Project: 08-25-3320 HCA LSMC DIETARY EXPANSION
2100 SE BLUE PARKWAY
LEE'S SUMMIT, Missouri 64063

RFI #049: Canopy Concrete Pedestal Dimension and Cladding

CANOPY COLUMN

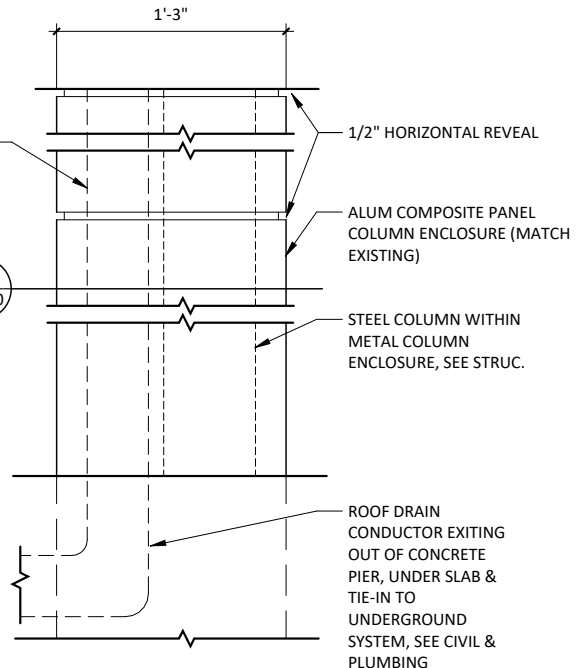
Drawing S201, Detail 12 show the concrete pedestal, on detail 9 it shows 1' - 3" please provide clarification on concrete pedestals dimension. We checked AE450 (Details 8 and 9) and we could see that the pedestal will get aluminum composite metal wall paneling that will be 1'-6" x 1'-6", but we did not see the dimensions for the concrete pedestal. Please advise.

THE ARCHITECT TO CONFIRM THE DIMENSION OF THE PEDESTAL REQUIRED UNDERNEATH THE METAL STUD FRAMING. PROVIDE 4#5 BARS IN THE PEDESTAL PER DETAIL 12/S201. THE CLEARANCE BETWEEN THE STEEL COLUMN AND BAR SHOULD BE AT LEAST 4". PROVIDE THE EXTERIOR CLEAR COVER PER S011.

SECTION AT CANOPY COLUMN

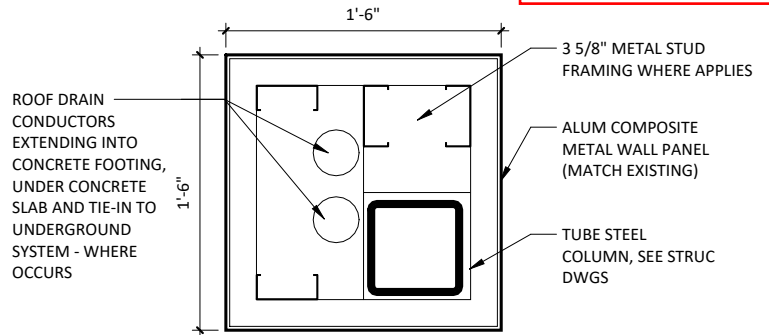
Can you also confirm that the aluminum composite metal wall paneling will be installed instead of the EIFS called out in S201?

Can you tell us this dimension?
